Environment, Development and Transport Committee

9 Hardings Way South, King's Lynn Traffic Regulation Order (Page **A3**)

Report title:	Hardings Way South, King's Lynn Traffic Regulation Order
Date of meeting:	6 July 2018
Responsible Chief Officer:	Tom McCabe - Executive Director, Community and Environmental Services
Strategic impact	
<p>As the Highway Authority in Norfolk, it is the County Council's responsibility to manage and administer the highway network. This includes regulating the activities of developers in relation to the highway.</p>

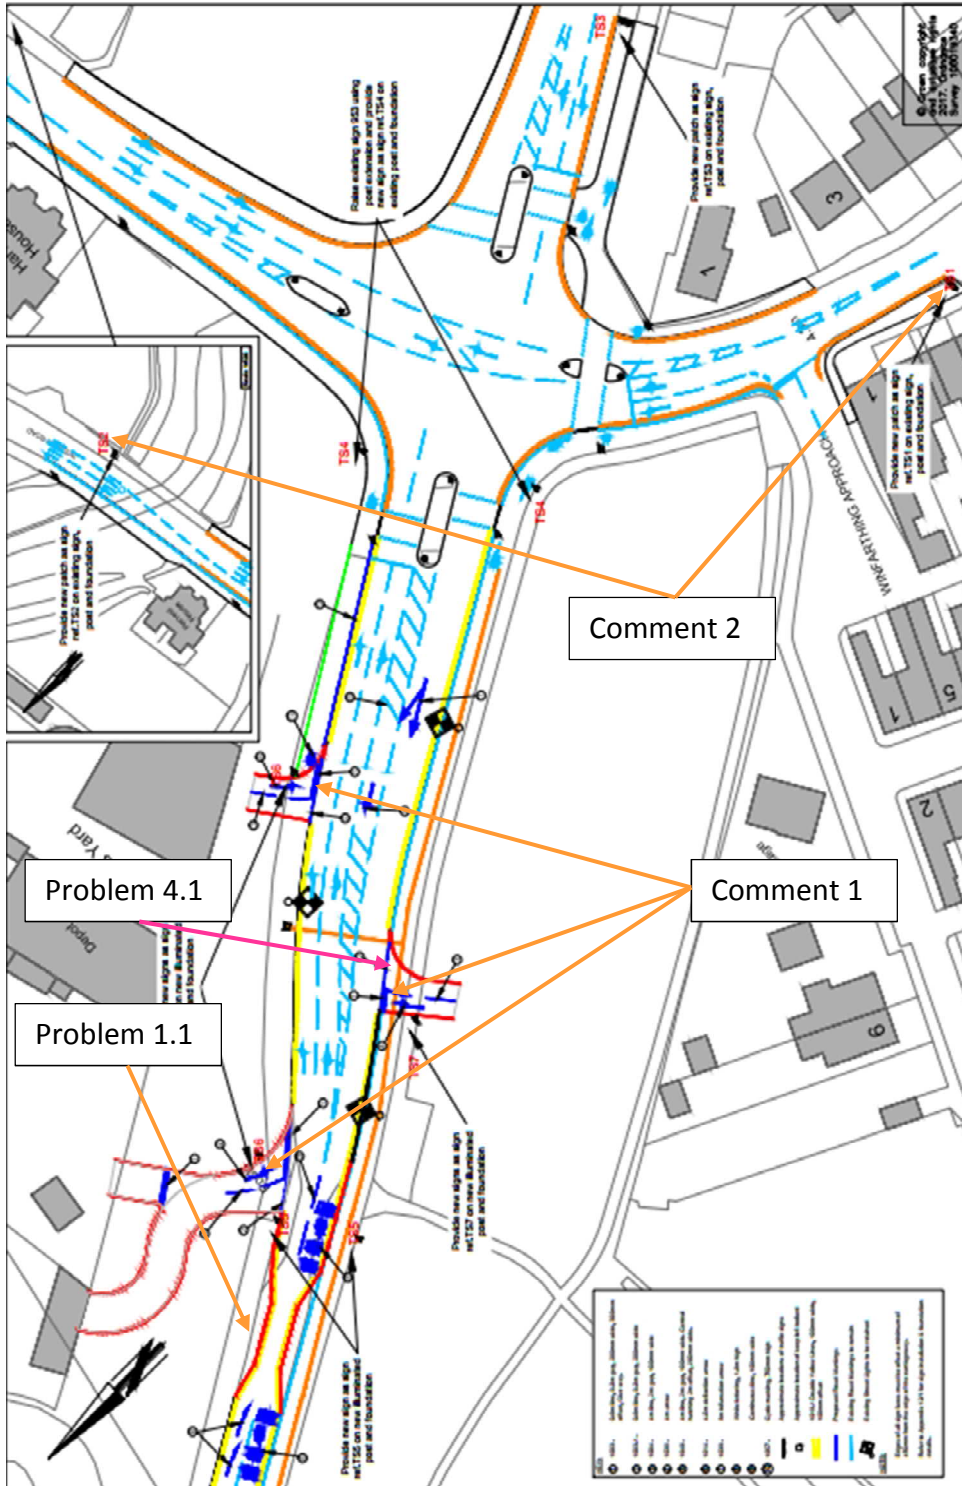
Recommendation – given the low levels of anticipated usage here, the shared use facility should be given priority, continuing unbroken across the access, with the associated give way lines for the vehicular access set back.

Agreed - The associated give way lines on the western proposed access will be moved further behind the shared-use facility allowing the facility to continue unbroken across the access. Similar facility will be provided on remaining two accesses on eastern side as well given proposed shared use facility on that side.

Network Management Decision: Accepted, no further comment.

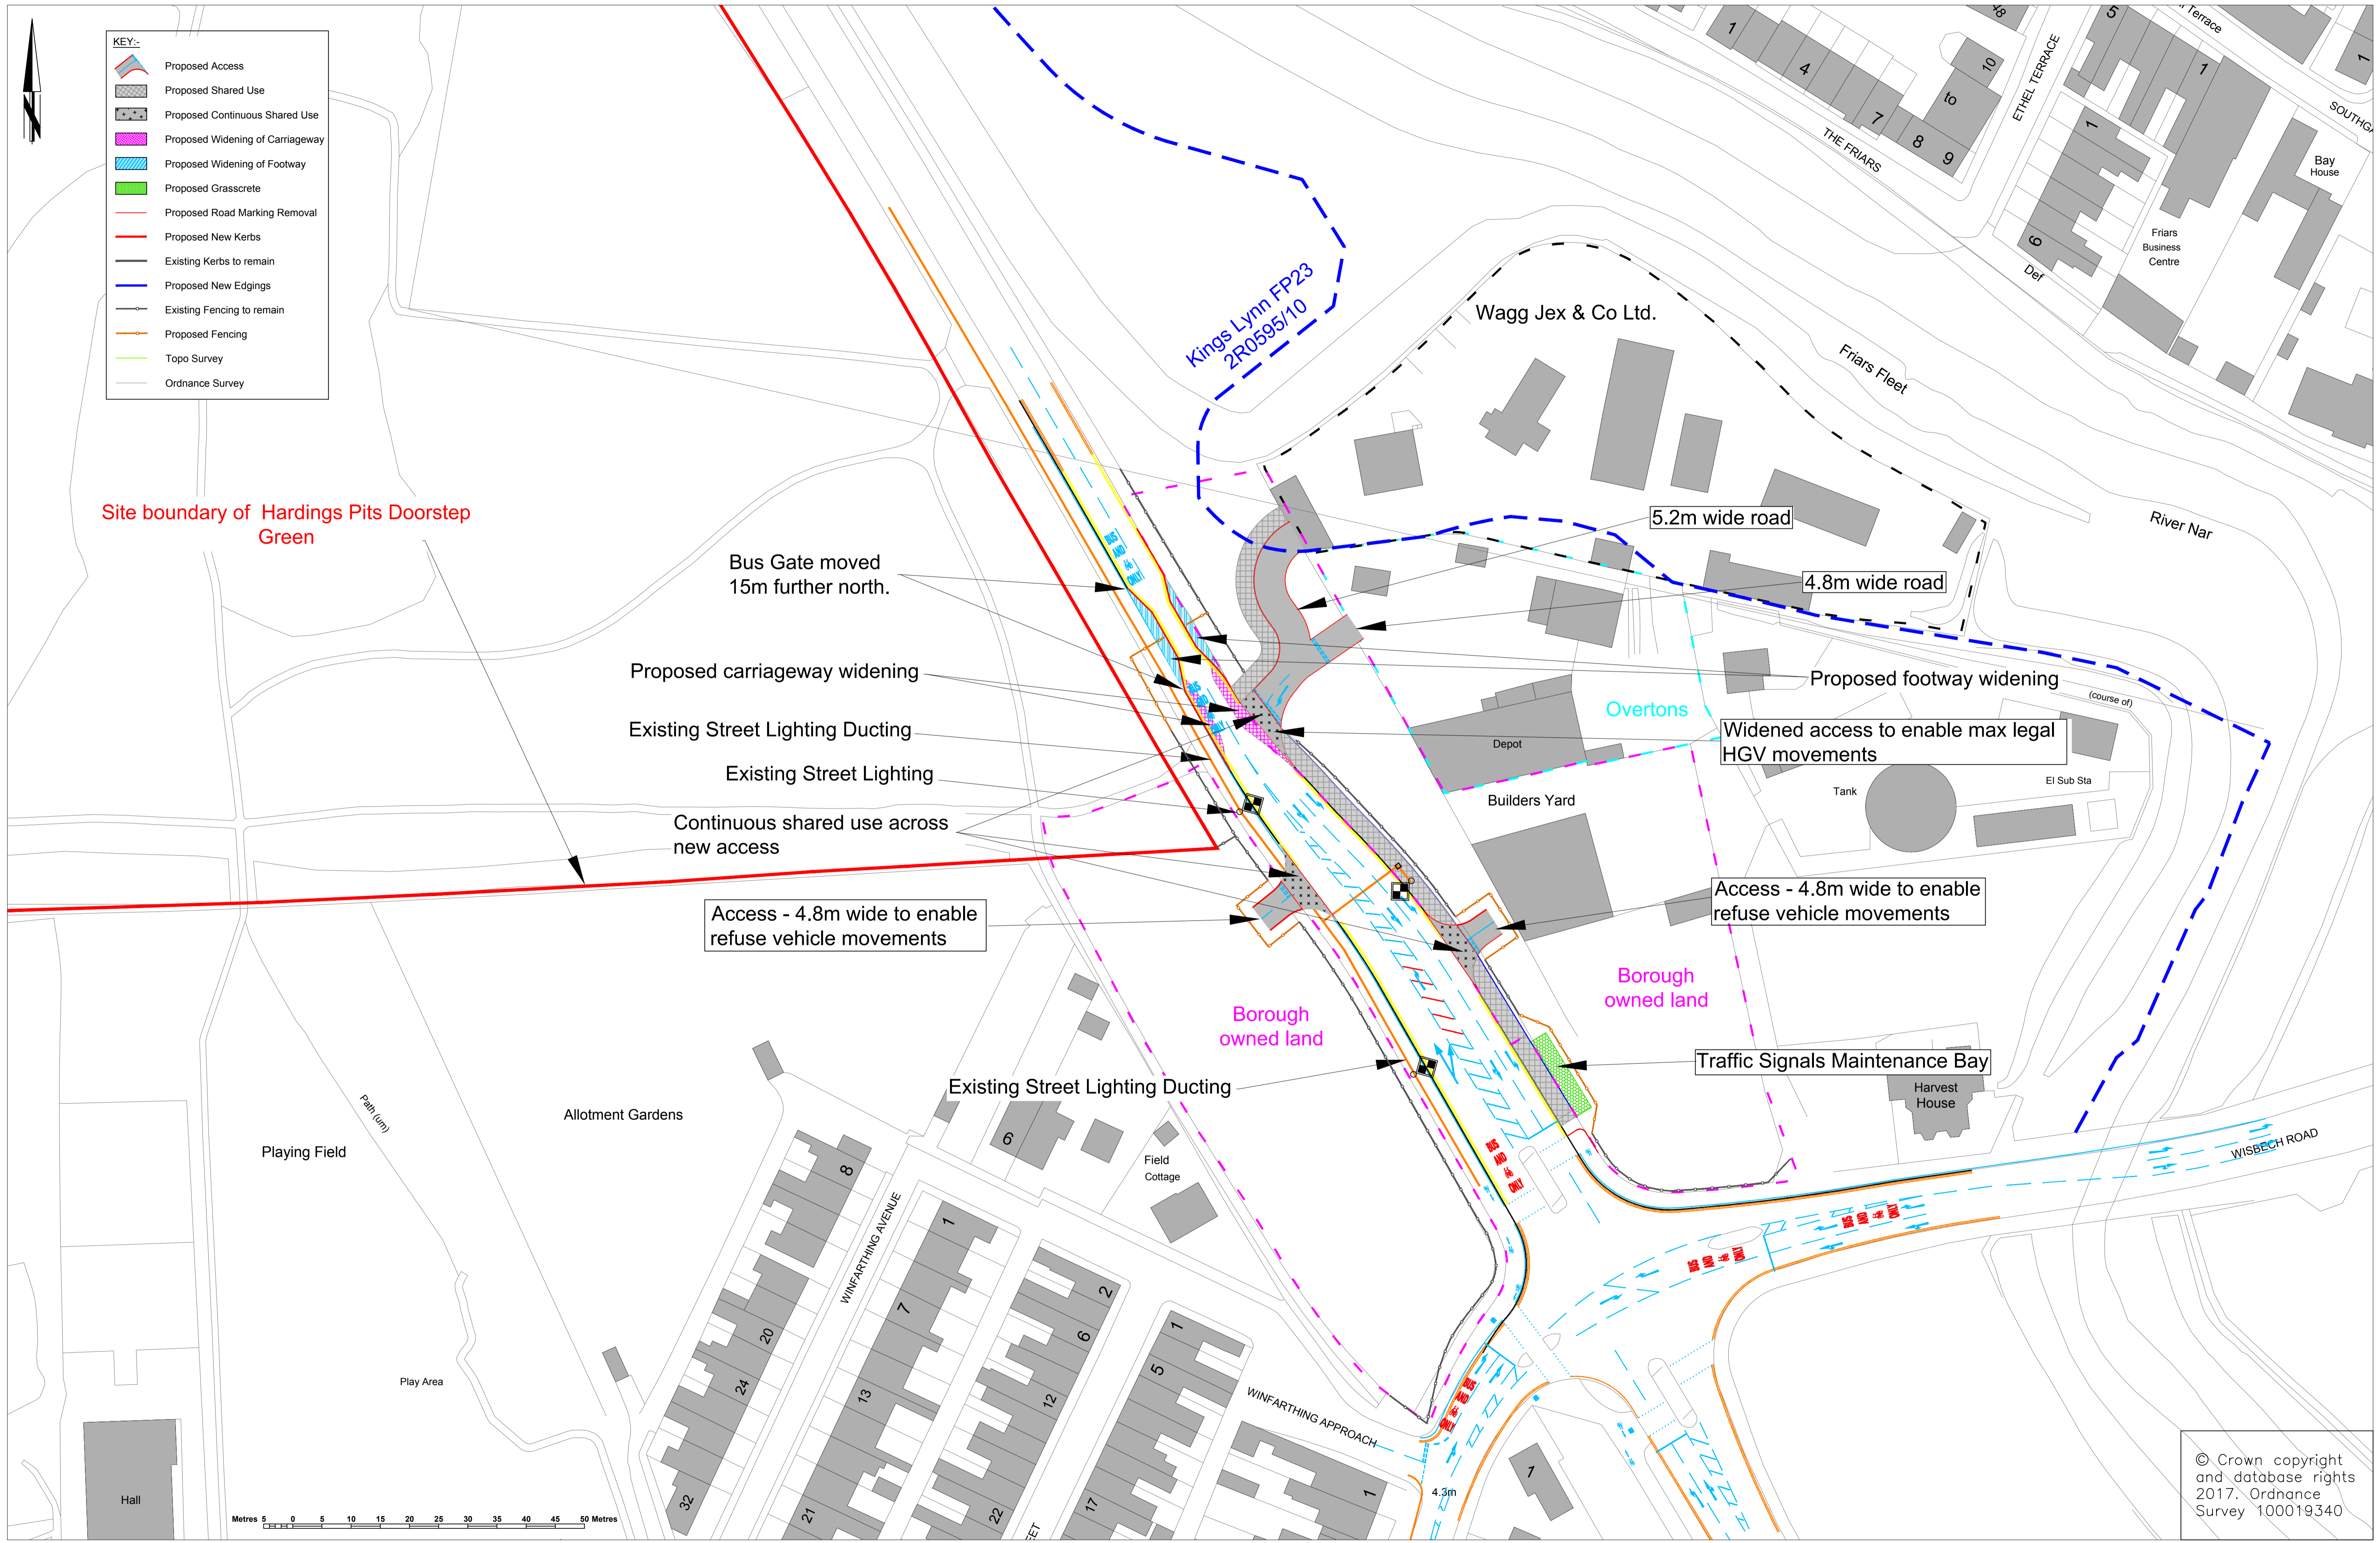
C.1 The scheme proposes right and left turn bans to deter vehicles from heading in the direction of the bus gate. A side effect of these bans would be to constrain the order in which a driver may use multiple accesses. The bus gate physically stops illegal usage and the scheme would not suffer if these bans, and associated signing, were omitted.

Noted - The right and left bans to deter vehicles from heading in the direction of the bus gate will be removed and adjacent corner radii increased.
